# Regulation 95 Front Plate Elongation Requirement Review

Presented to GRSP 6 December 2021  
By Plascore, Inc.

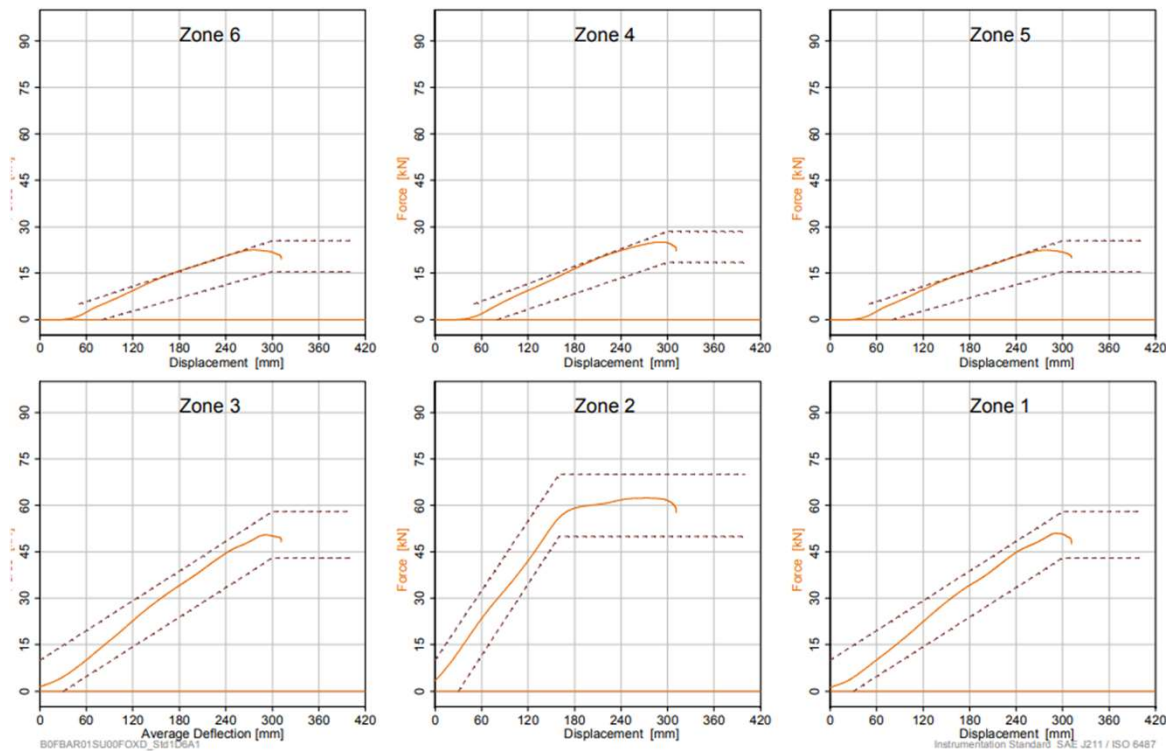
In our opinion, the lower elongation at break % for 5052-H32 should not be considered to disqualify 5052-H32 as an equivalent front plate material to AlMg<sub>3</sub>.

During verification testing of the barrier, the front plate is not subjected to any significant distortion as it is projected against a flat surface.

3<sup>rd</sup> Party Testing of ECE-R95 WG13 Barrier with 5052-H32 Front Plate and 6.4% Elongation passes all barrier level testing.

We request a change in Regulation 95 paragraph 2.2.2.1 front plate elongation at break requirement from  $\geq 12\%$  to  $\geq 5\%$  for material at 0.5mm thickness.
